A1.2

**TRAFFIC CIRCULATION LAYOUT
APPROVED**

SITE PLAN

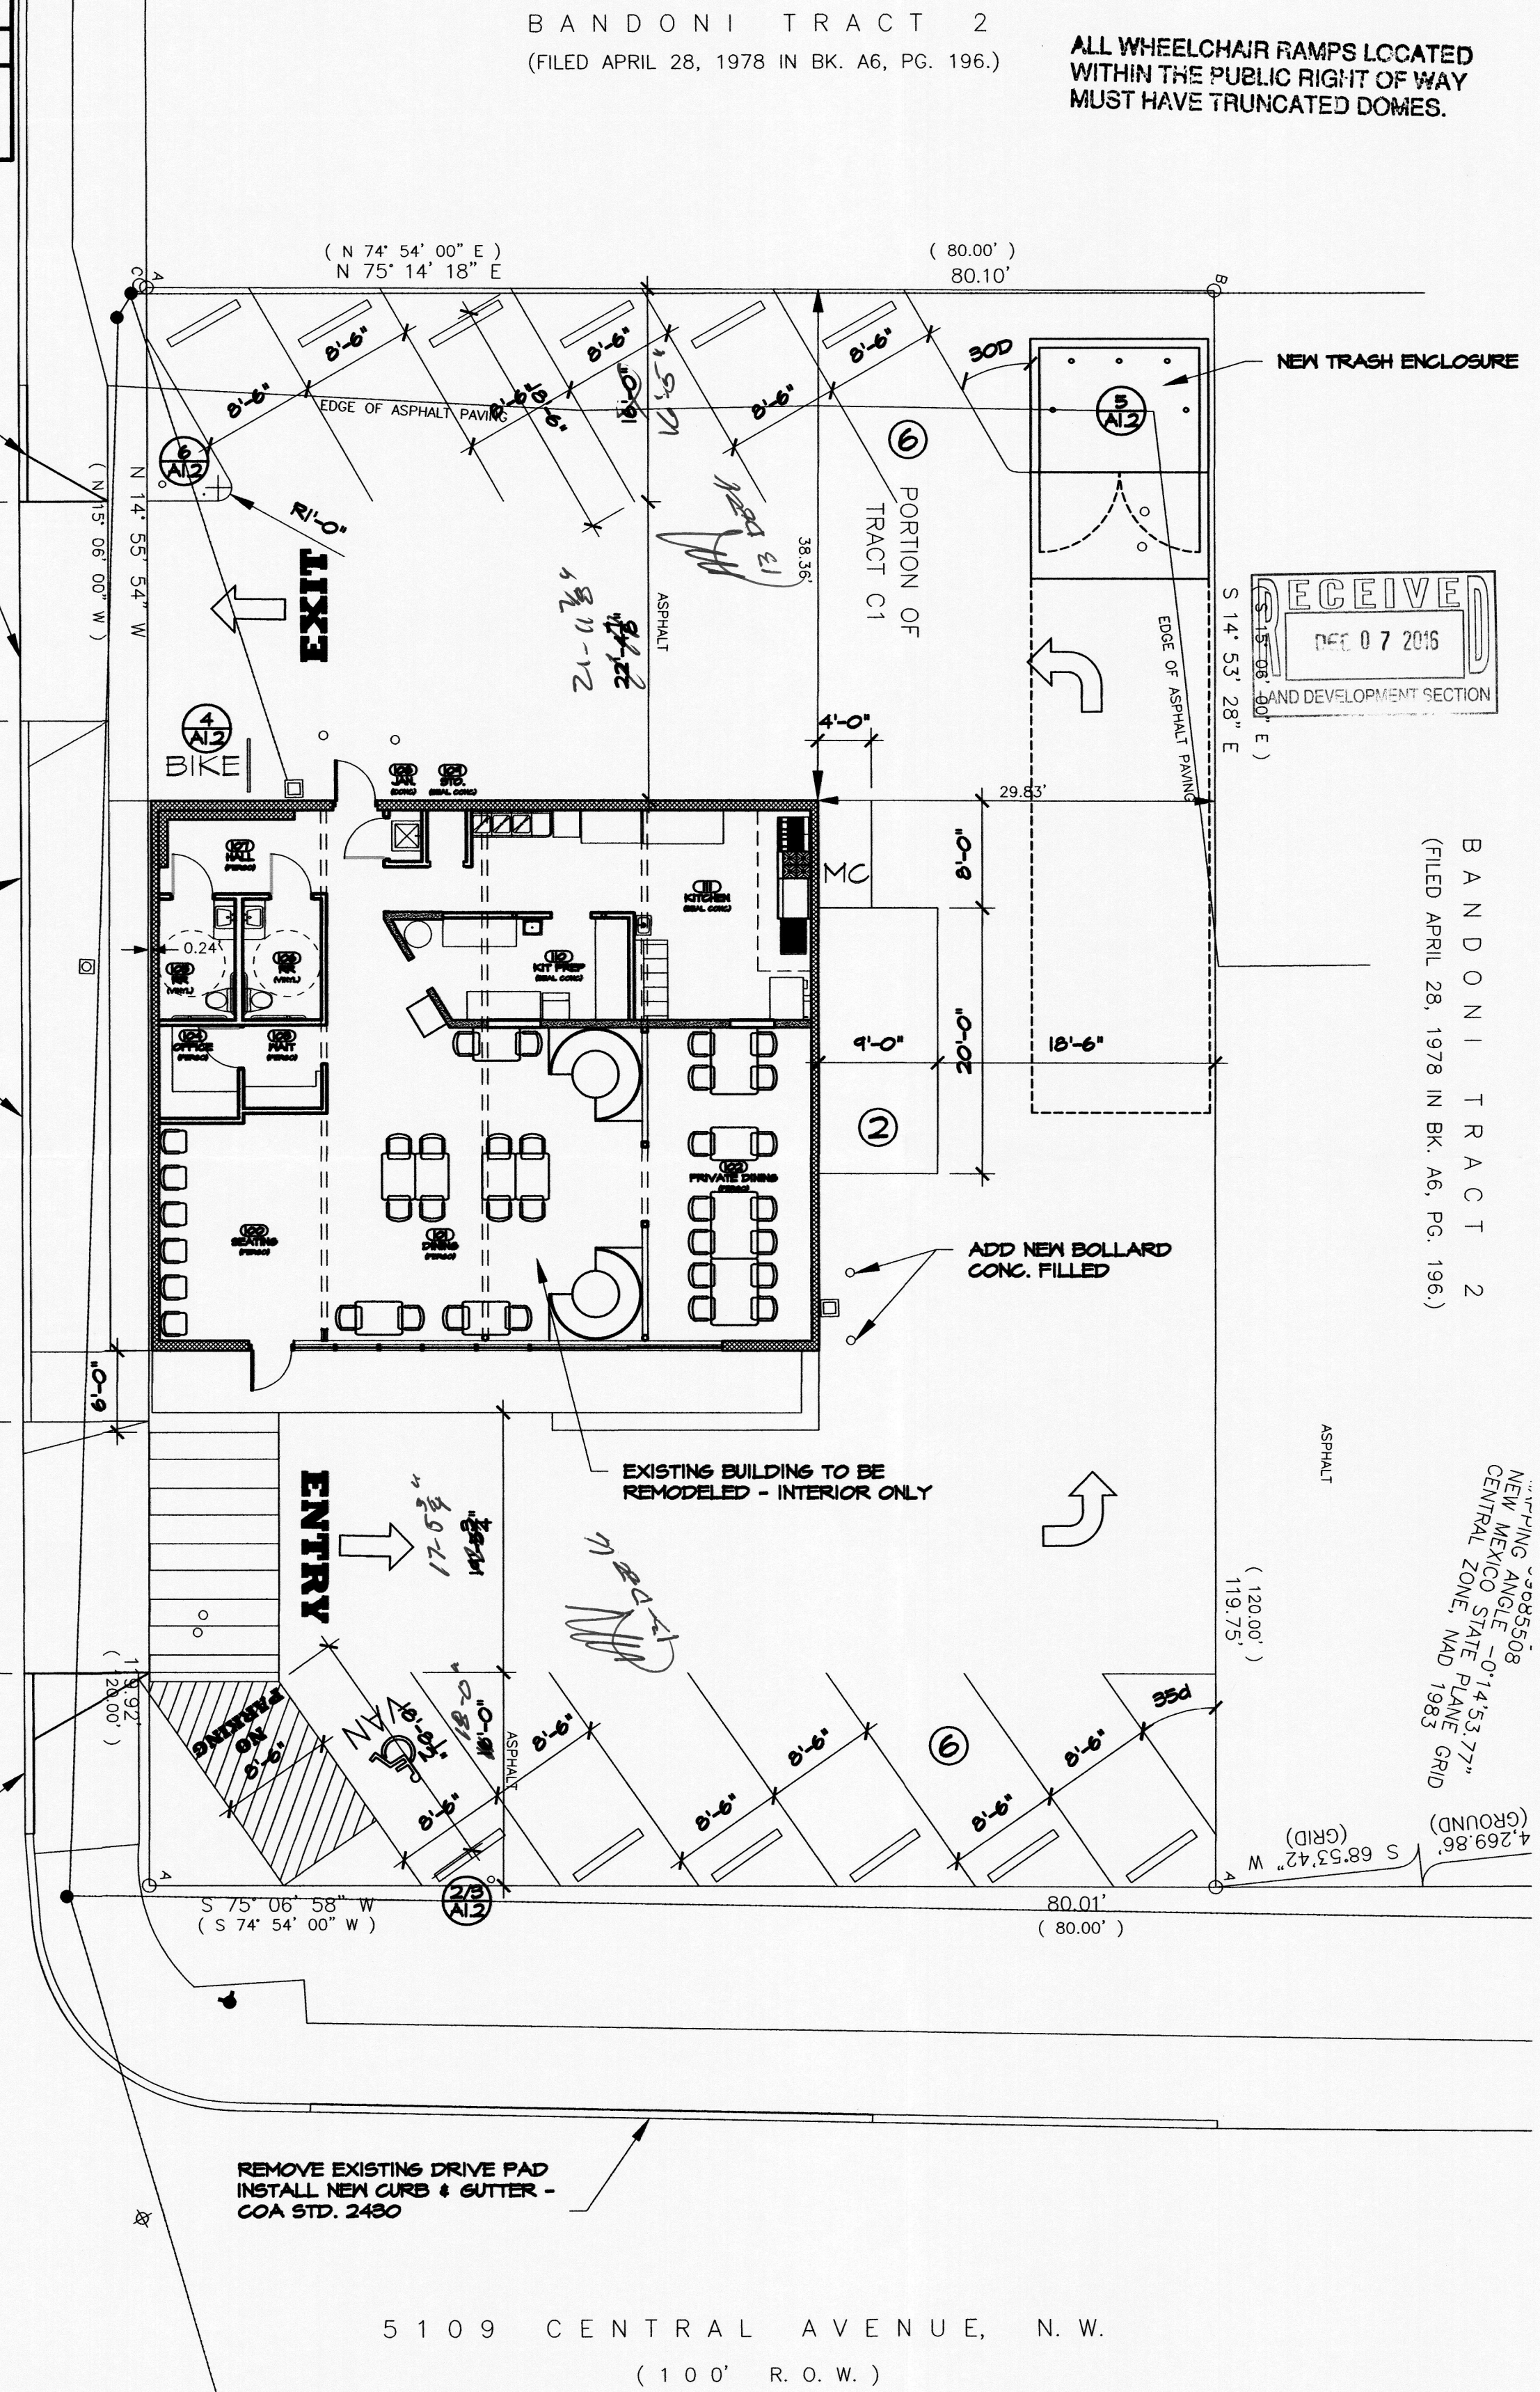
NEW DRIVEPAD
TO 16'-6" WIDE-
COA STD. 2425

ALL IMPROVEMENTS LOCATED
IN THE RIGHT OF WAY MUST BE
INCLUDED ON THE WORK ORDER.

ALL BROKEN OR CRACKED
SIDEWALK TO BE REPLACED
WITH SIDEWALK AND CURB &
GUTTER - COA STD. 2430

INSTALL NEW
GUTTER -
COA STD. 24

INSTALL NEW
GUTTER -
COA STD. 24
